**LODI UNIFIED SCHOOL DISTRICT**  
**2019 PAVING PROJECTS – PHASE 1**

**ADDENDUM NO. 1**

March 18, 2019

Sketch SK-1

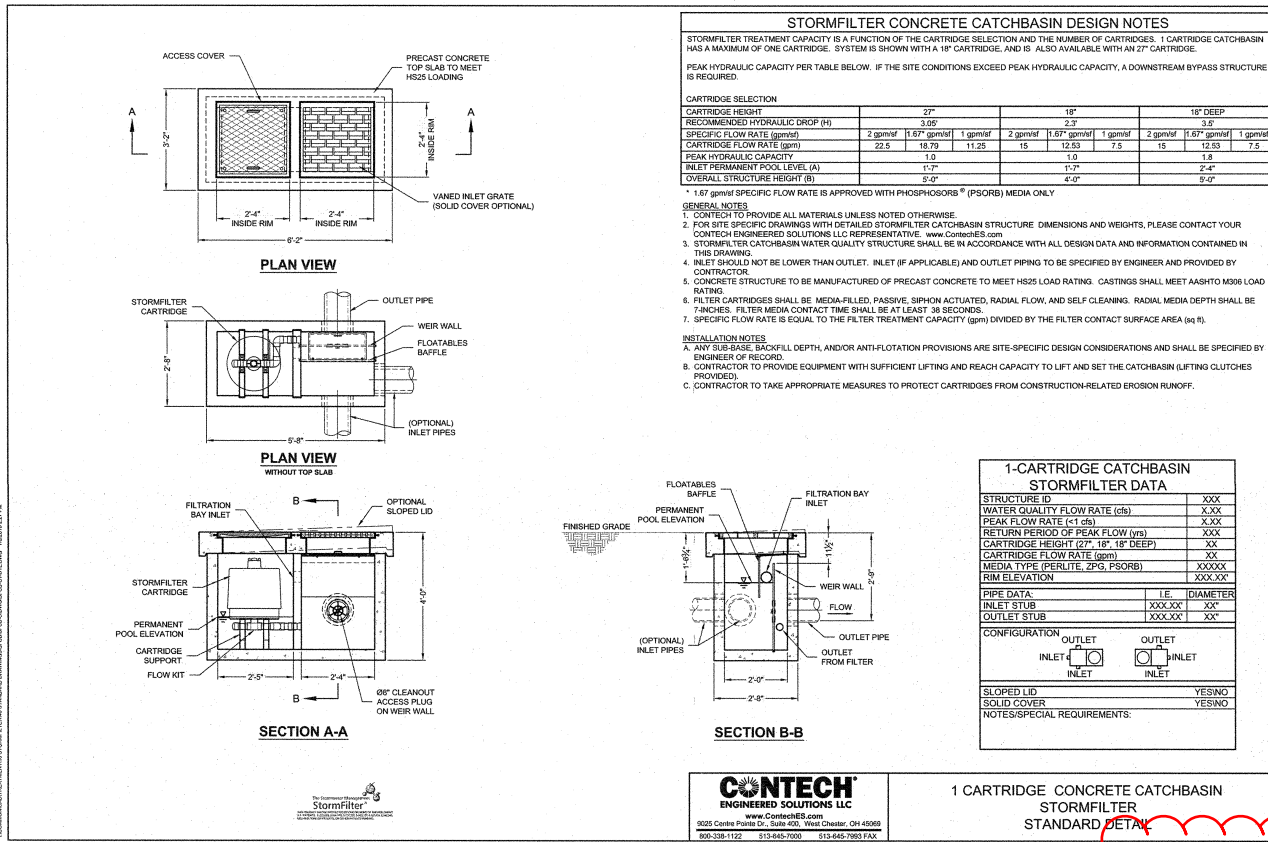
1.13 Refer to Live Oak project, see Sheet C2.1 for trash enclosure, and see new sketch SK-1 with layout/dimensions and notes.
